Technical Service Bulletin: TSB180033

Additional Pre-Lubrication Switch

- QSK60 CM850 MCRS
- QSK60 CM2150 MCRS

Figure 1, (1) Pre-Lube Pressure Switch, Part Number 4924925, (2) Reducing Adapter, Part Number 3976110.

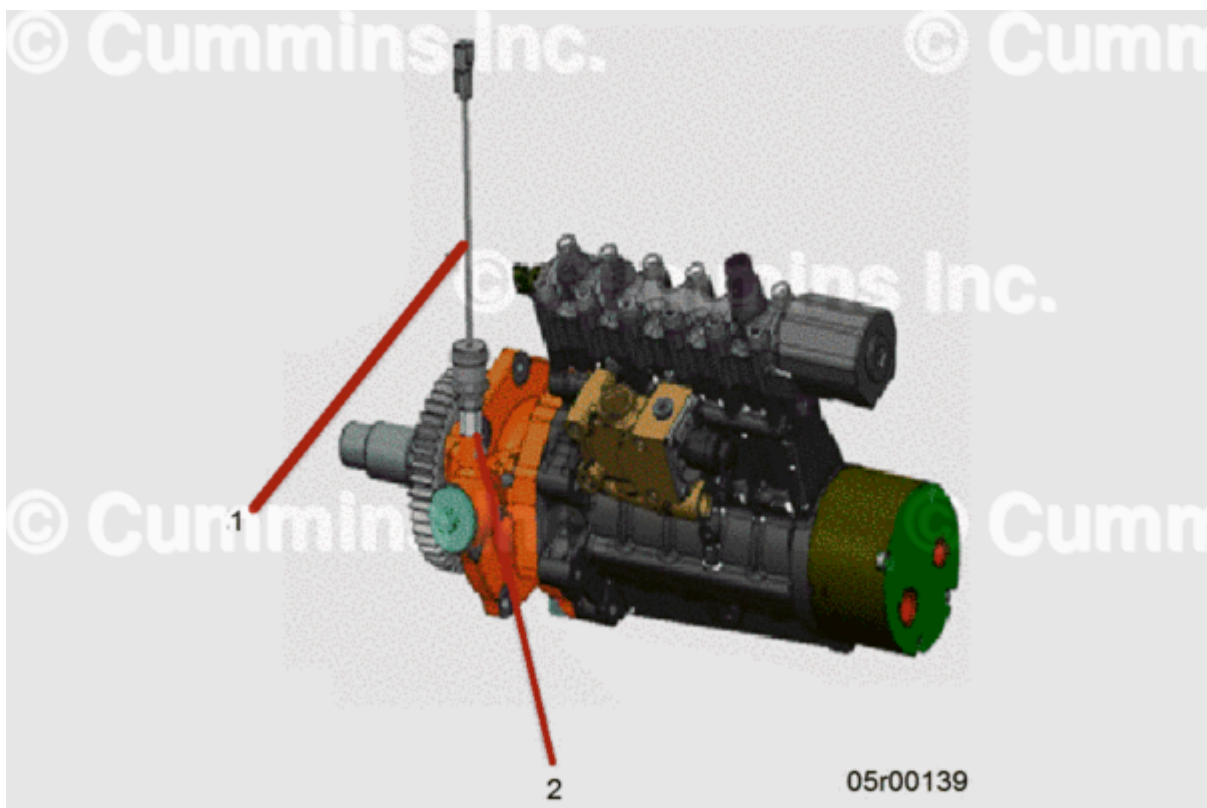
In order to up-fit additional pre-lube oil pressure switch on engines in the field, an adapter must be installed into the fuel pump drive. See Figures 1 through 7.

Figure 2, Connection at Existing Oil Pressure Switch Plug.

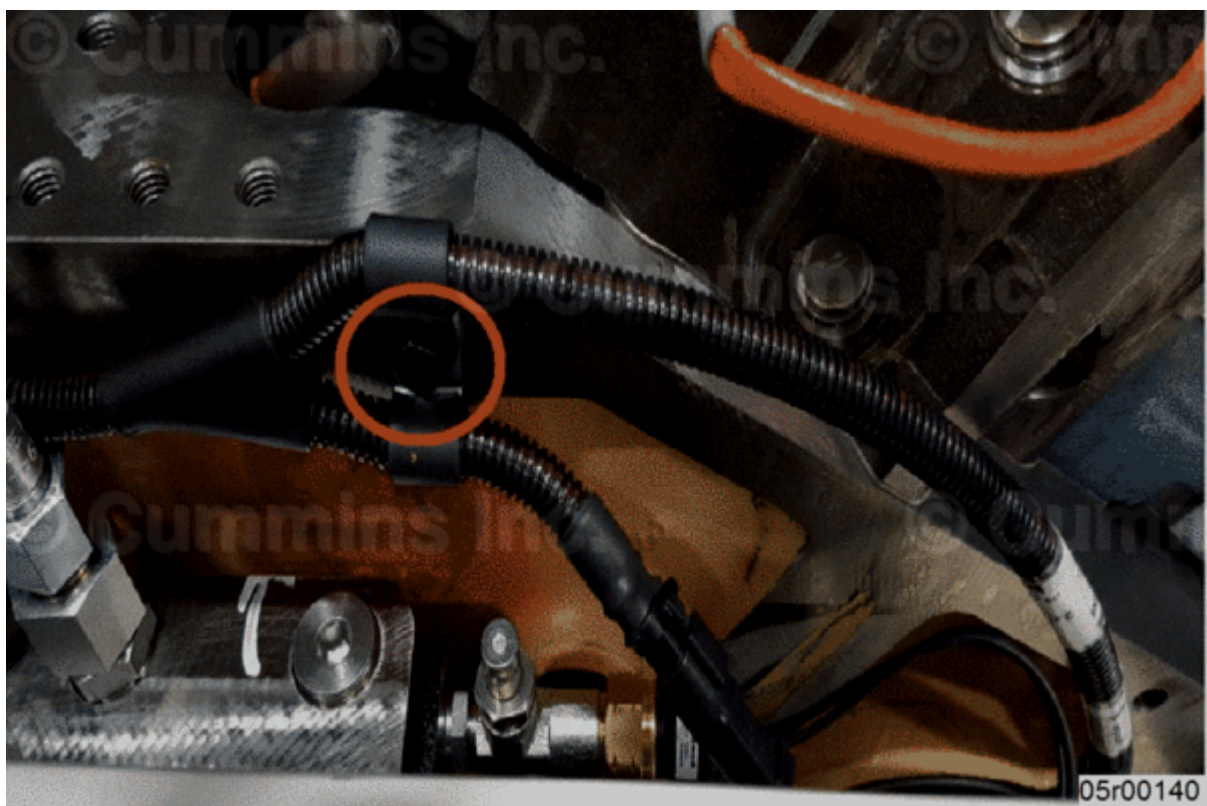
1. Connect existing oil pressure switch plug. Use Part Number 3903990. See Figure 2.
2. Route wire harness across rear of block. See Figure 3.
3. Use capscrew Part Number 3093923 to secure harness. See Figures 4, 5, and 6.
4. Connect oil pressure switch, Part Number 4924925, to wire harness, Part Number 5417037. See Figure 7
5. Install reducing adapter, Part Number 3976110, and oil pressure switch, Part Number 4924925, into fuel pump drive adapter.
